<b>ADDENDUM NO. :</b>	<b>Four (4)</b>
<b>BID DUE TIME AND DATE:</b>	2:00 p.m., April 30, 2019 <b>(No Change)</b>
<b>BIDDER QUESTIONS BY:</b>	11:59 a.m., April 23, 2019
<b>LAST ADDENDUM ISSUED:</b>	11:59 p.m., April 25, 2019

**THE PURPOSE FOR THIS ADDENDUM IS:**

- **To provide a response to questions raised by Plan Holders;**
- **To modify/clarify specifications and drawings.**

**A304**

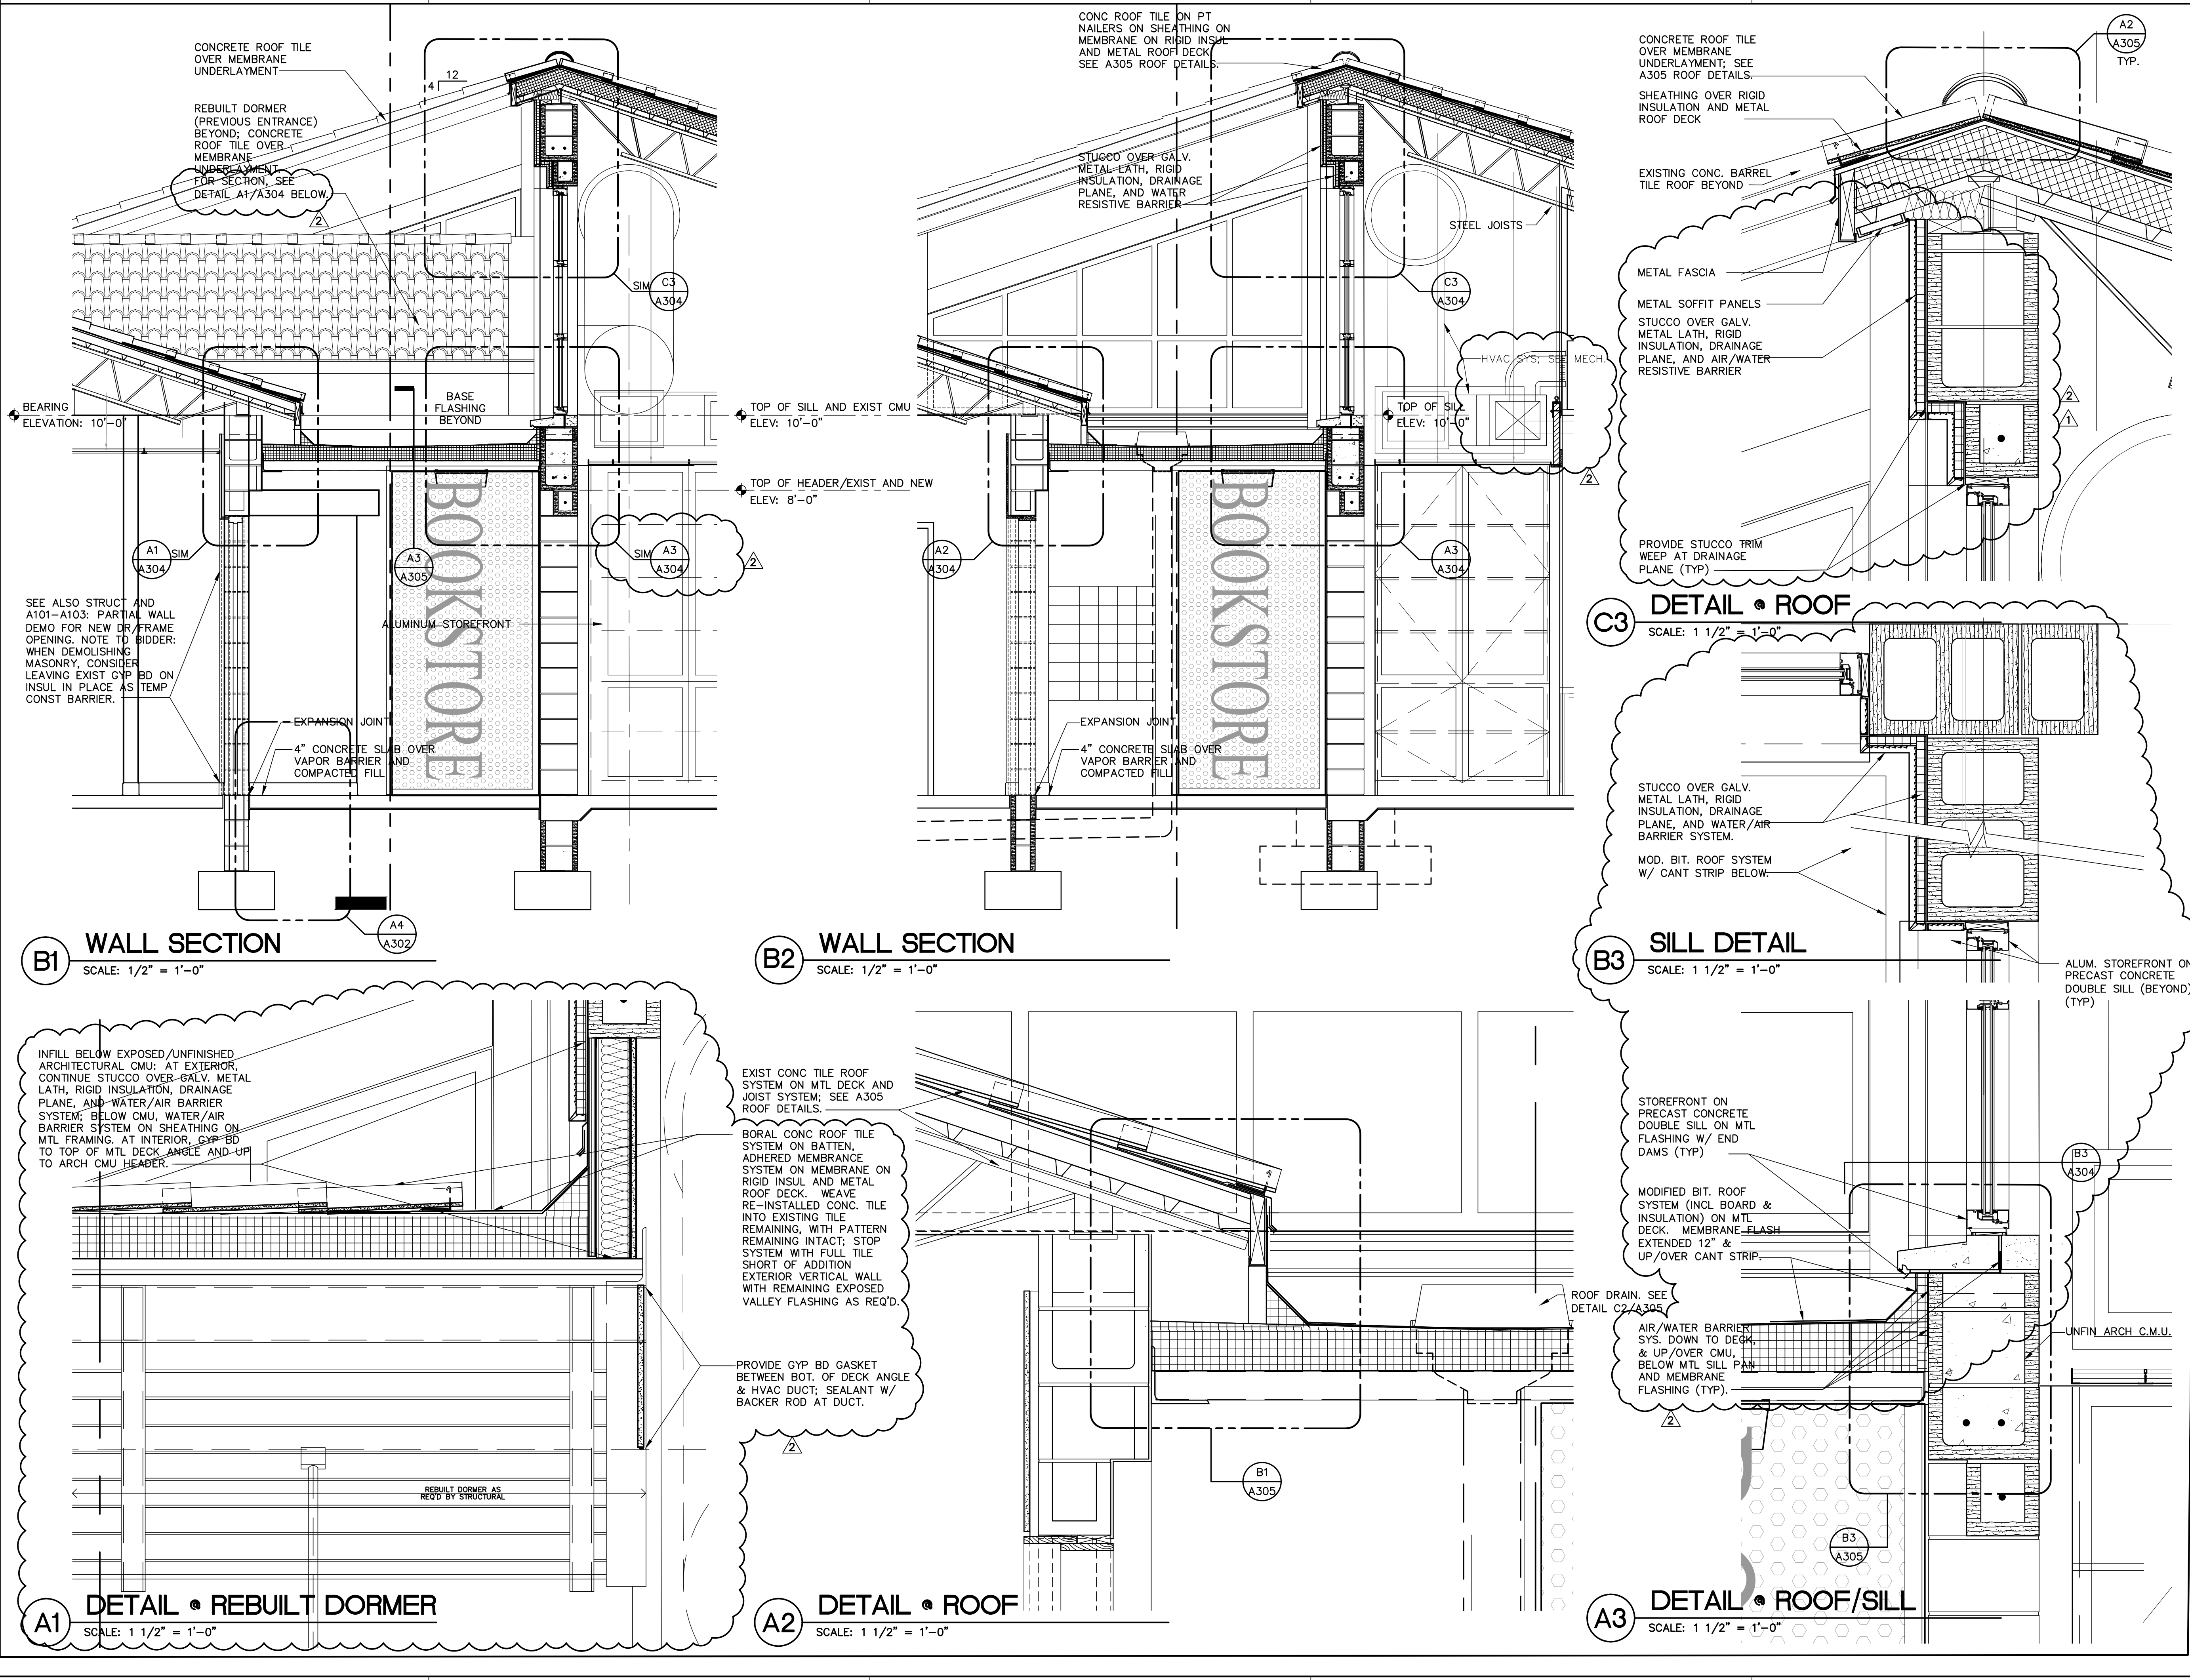
- A301 Building Sections
- A302 Building Sections
- A303 Ext Wall Sections & Details
- A304 Ext Wall Sections & Details
- A306 Ext Wall Sections & Details
- A502 Ceiling Details
- A601 Finish Schedule w/ Details
- P101, Updated plan to show missing fixtures and missing sanitary and vent piping
- P102, Updated plan to show missing fixtures, missing domestic water piping and missing gas piping
- P101, Updated plan to show missing fixtures and missing sanitary and vent piping
- P201, Updated plan to show missing fixtures and missing sanitary and vent piping
- P202, Updated plan to show missing fixtures, domestic water piping and missing gas piping
- M401, Added detail for chilled water connections to AHU
